MERRION OIL & GAS CORPORATION WELLBORE SCHEMATIC

Glade Park No. 2

Proposed Wellbore Configuration

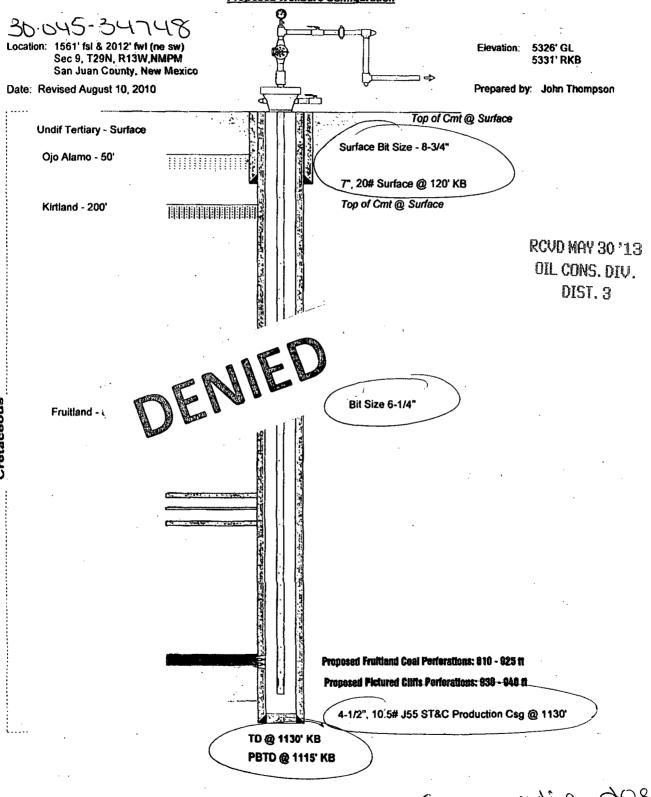
In-Correct Information - Schematic does Not mater casing drilling sundry.
